INCH-POUND
MIL-C-1238
AMENDMENT 2
9 July 1993
SUPERSEDING
AMENDMENT 1
15 July 1991

MILITARY SPECIFICATION

CAPACITORS, FIXED, CERAMIC DIELECTRIC,
(TEMPERATURE STABLE AND GENERAL PURPOSE), HIGH RELIABILITY,
GENERAL SPECIFICATION FOR

This amendment forms a part of MIL-C-1238, dated 6 August 1990, and is approved for use by all Departments and Agencies of the Department of Defense.

Example 6 "

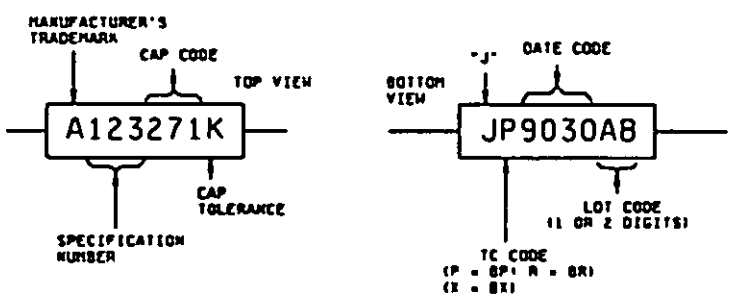
* FIGURE 3, example 6, delete in its entirety and substitute:

FIGURE C-7. Chip-outs. "

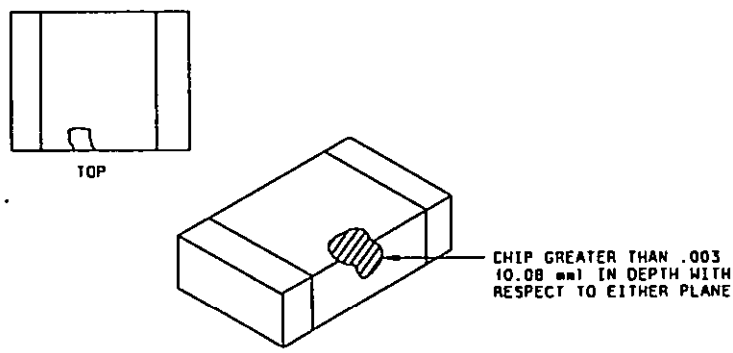
* FIGURE C-7, delete in its entirety and substitute:

* 30.2.2d, first sentence, delete and substitute:

"Edge chip-outs shall not be greater in depth than .003 inch (0.08 mm) with respect to either plane."

FIGURE D-1. Lead-pull direction."

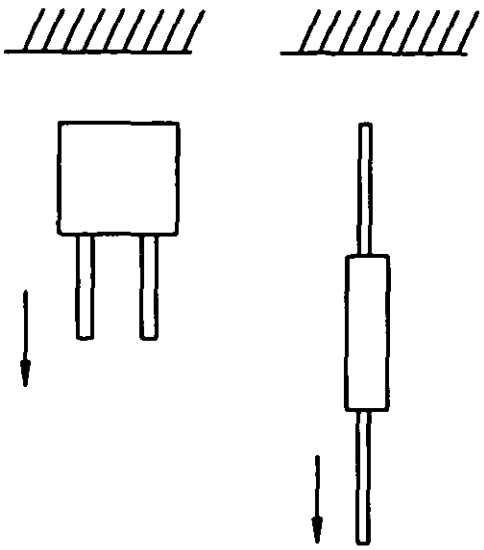
* FIGURE D-1, delete in its entirety and substitute:

* 40.2, delete in its entirety and substitute:

"40.2 Axial devices. Firmly clamp both leads into the test fixture. Gradually apply an increasing force (see figure D-1) until the limits specified in table XIV are exceeded".
